**TOWN OF MOUNTAIN VILLAGE
REGULAR DESIGN REVIEW BOARD MEETING AGENDA
THURSDAY AUGUST 1, 2024, 10:00 AM
MOUNTAIN VILLAGE TOWN HALL
455 MOUNTAIN VILLAGE BLVD, MOUNTAIN VILLAGE, COLORADO
TO BE HELD HYBRID THROUGH ZOOM:
<https://us06web.zoom.us/j/88262566269>
Meeting ID: 882 6256 6269**

3.	10:02	30	Perez/ Applicant	Quasi-Judicial	Consideration of a Design Review: Final Architecture Review for a new single family detached condominium at Lot 649R, TBD Boulders Way Unit 11, pursuant to CDC Section 17.4.11.

FROM: Claire Perez, Planner II

1 LANDSCAPE PLAN
1/4" = 1'-0"

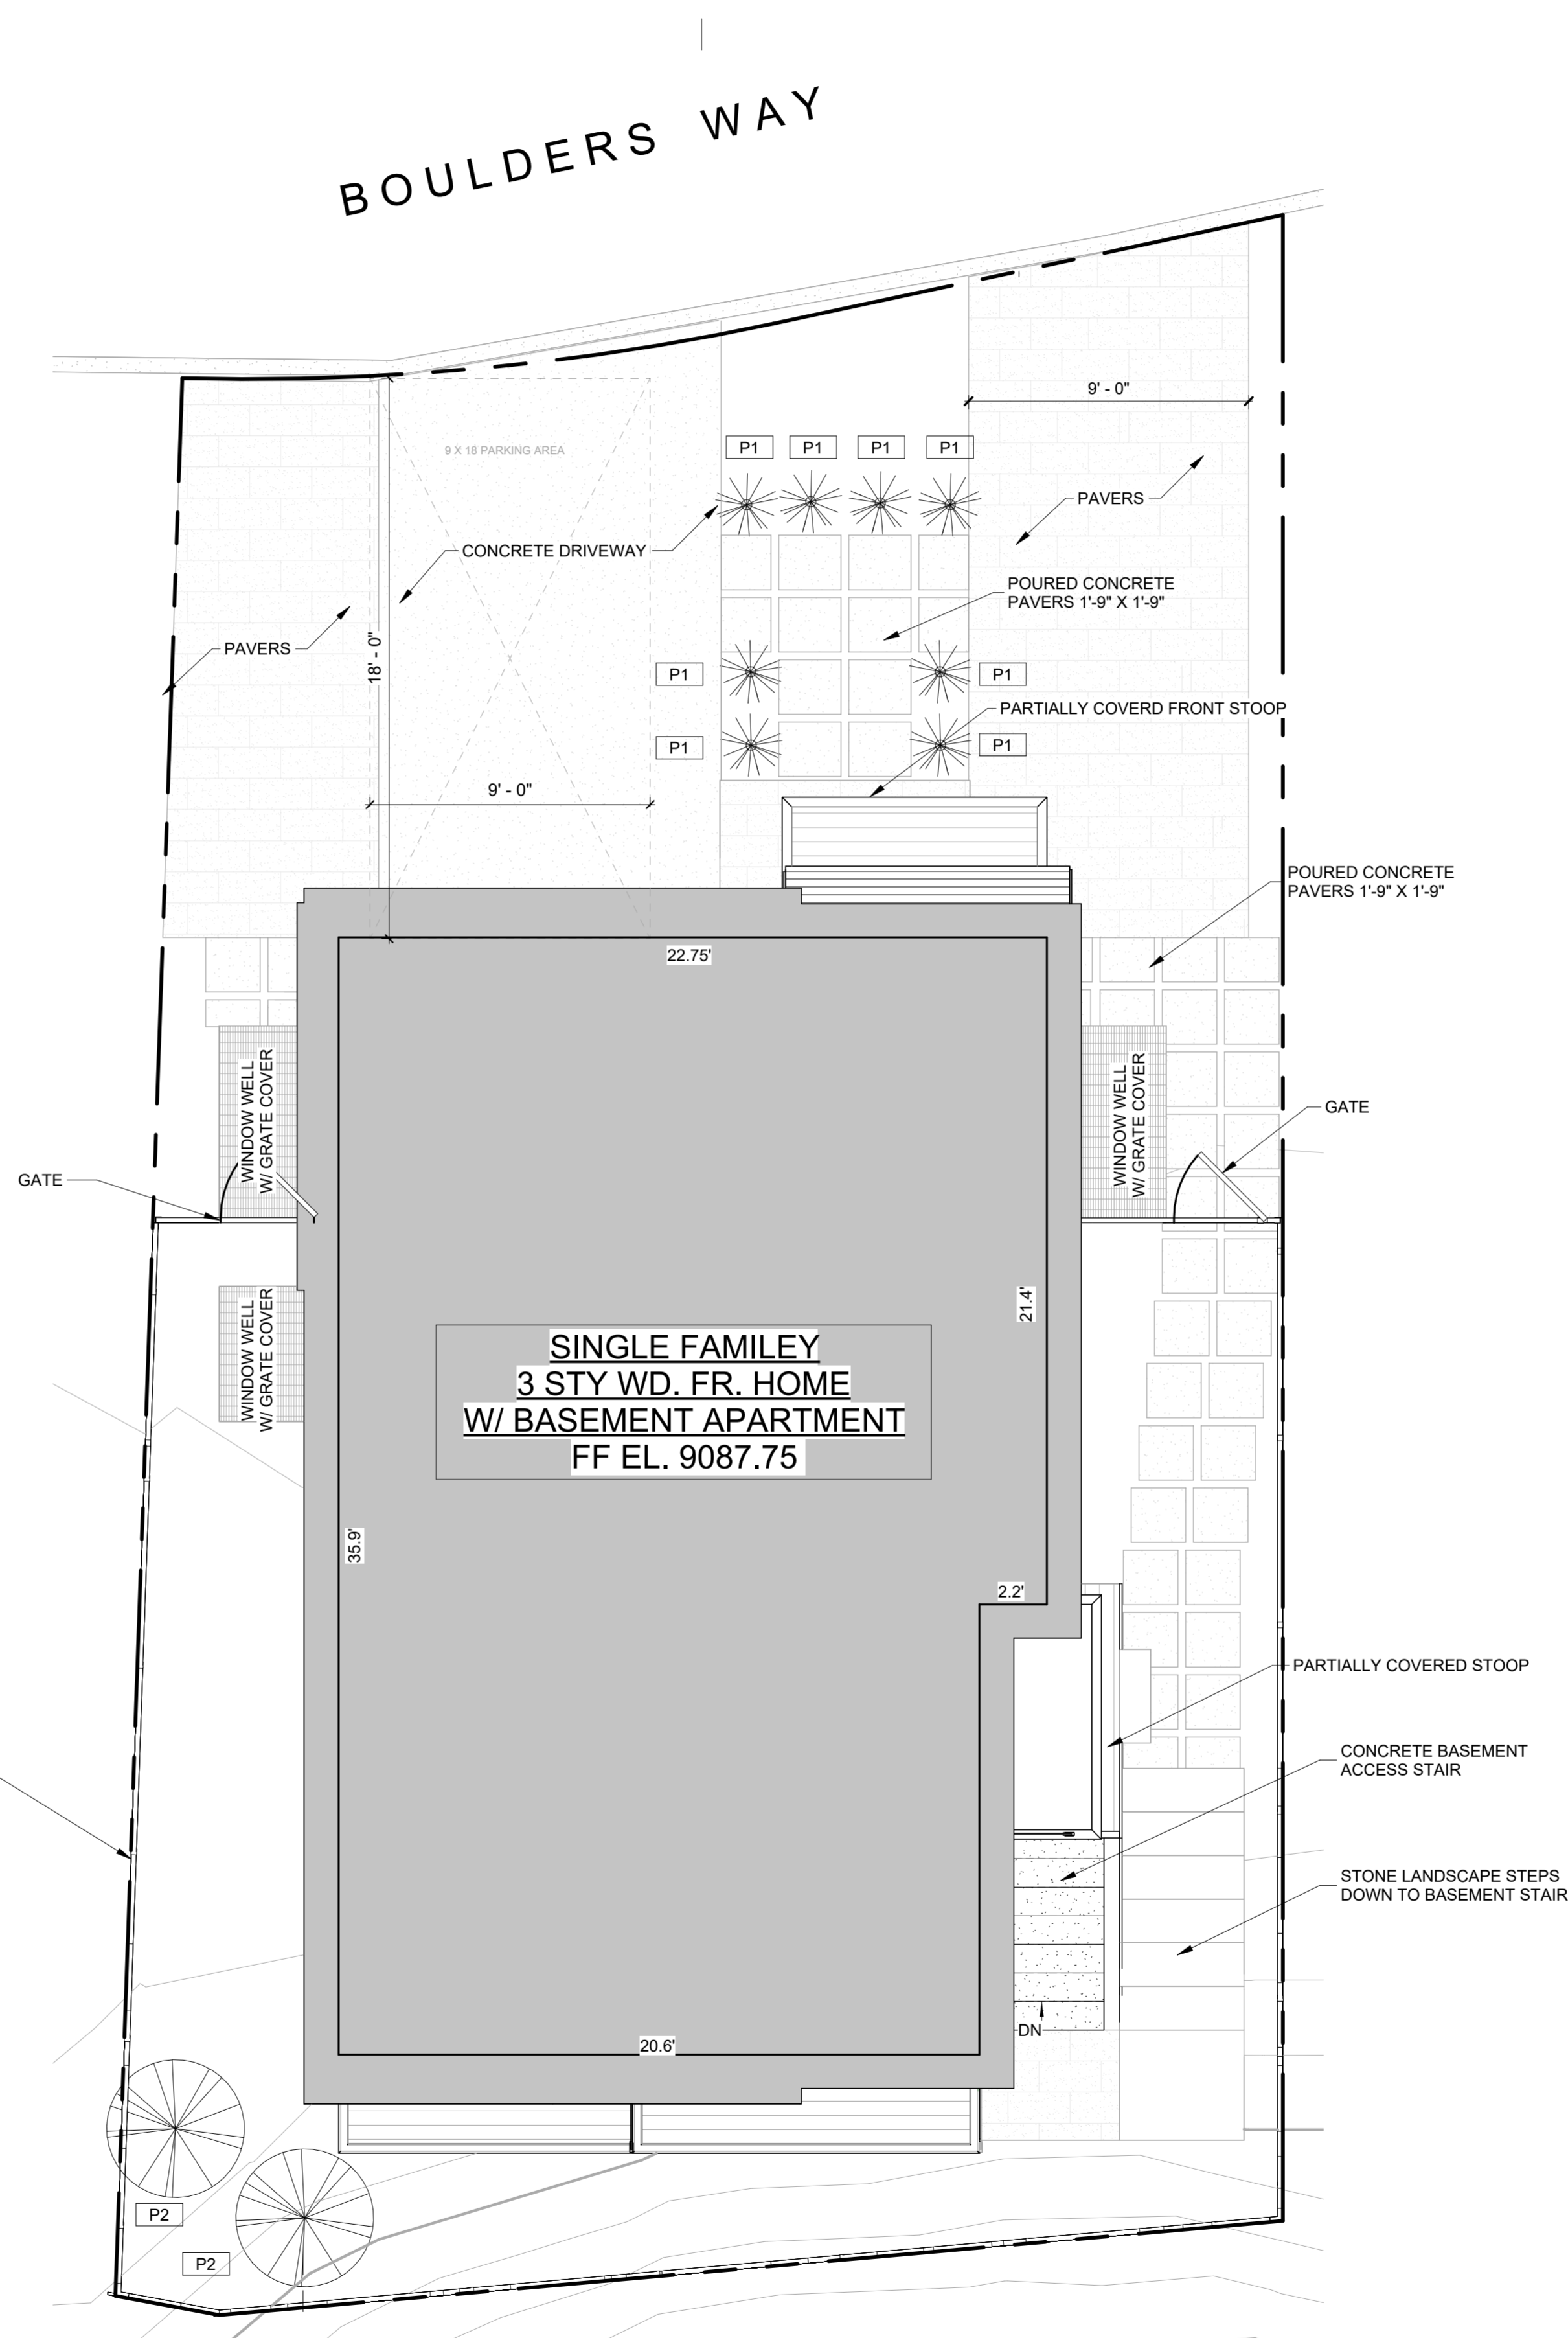
Staff: The applicant has provided a landscape plan on Sheet A1.2. There is no existing vegetation on site. The applicant has proposed planting 2 Aspen and 8 Woods Rose bushes on the site. The landscaping plan needs to be revised to include a tree planting detail that shows the proper steps required in planting trees/shrubs. The plan also needs a note that states that the burlap and wire basket must be removed to at least the top 12 -16 inches of the root ball. The plan should be amended per the Forester's comments prior to Final Review.

1 LANDSCAPE & IRRIGATION PLAN
1/16" = 1'-0"

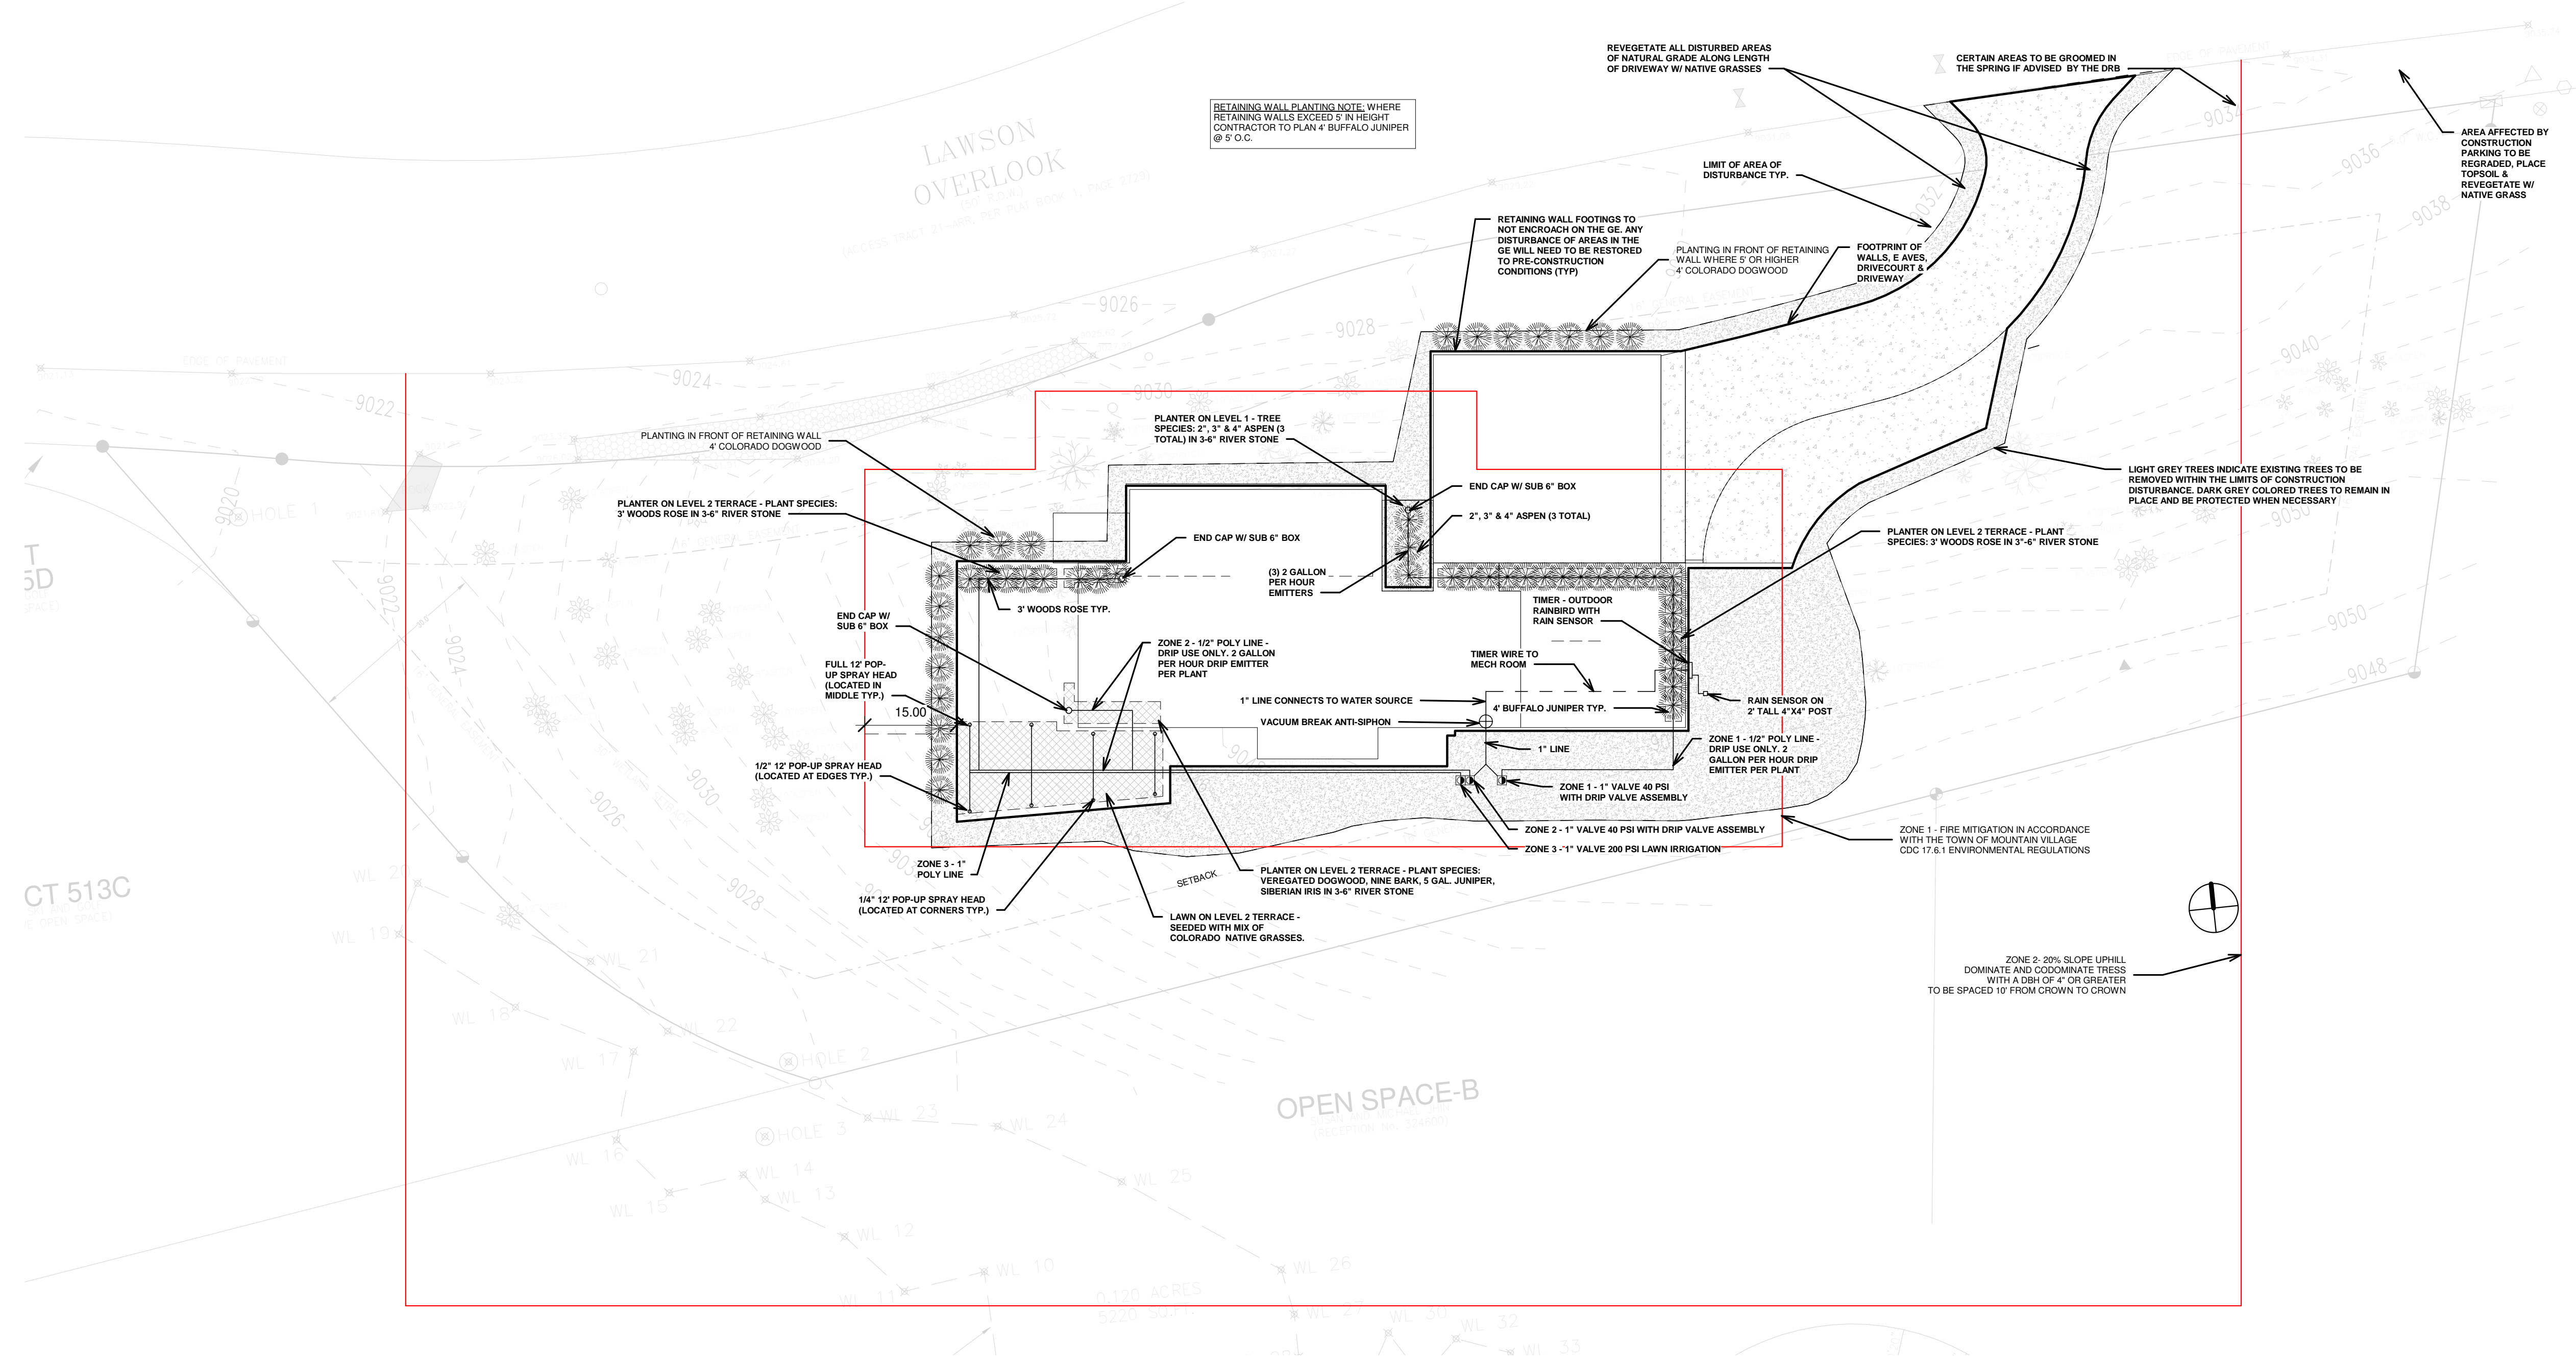
The landscape plan (Sheet A1.2) needs to show the location of where the limits of disturbance fencing will be placed. It needs a distance scale, and it also needs to indicate the location of tree protection fencing for all trees that will be retained within the limits of

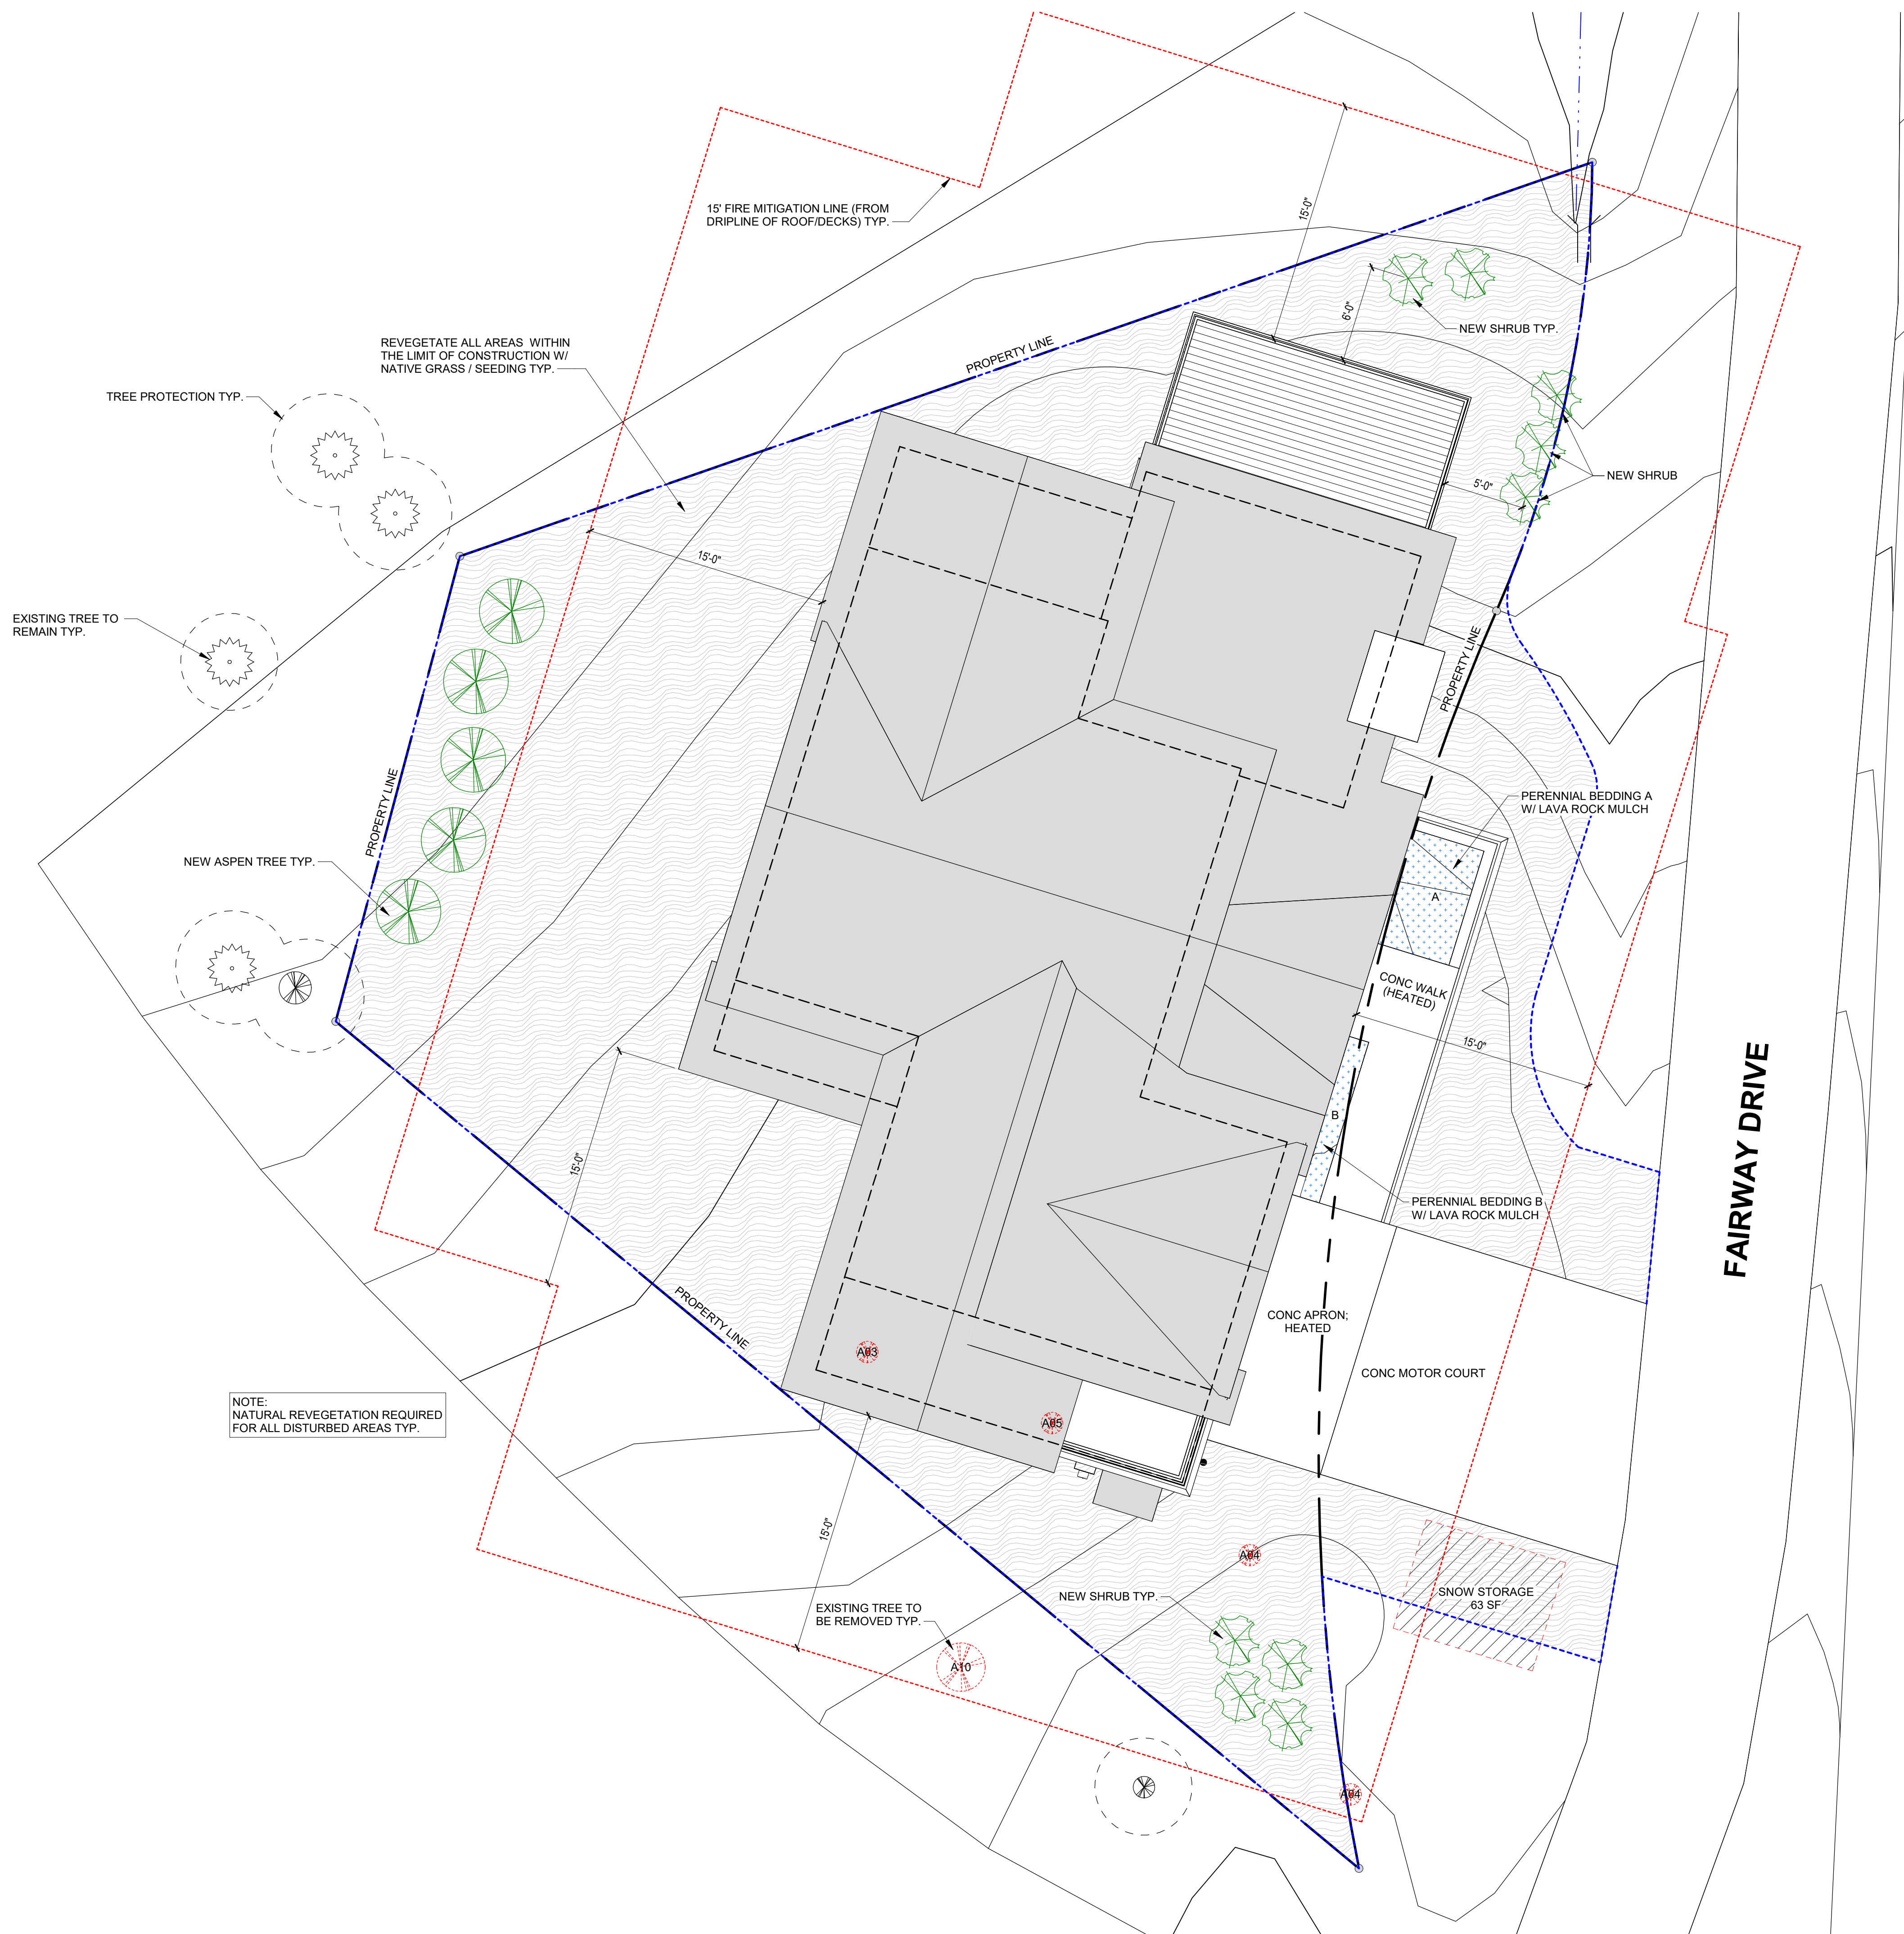
Staff: An initial landscaping plan was provided on Sheets A1.3 through A1.5. The applicant is proposing the addition of 5 Aspen trees or multi-stems, 9 chokecherry shrubs, and 76 square feet of perennial beds in the front of the home. One existing Aspen tree located within Zone 1 is proposed to be removed on the south side of the home.

“The landscape plan, sheet A1.3 needs to include a tree planting detail that shows the proper location of the trunk flare in relationship to the grade and other details such as planting hole shape, etc. This sheet also needs a note stating that “all trees to be retained must have tree protection fencing installed at the dripline of the trees or beyond before excavation may begin.
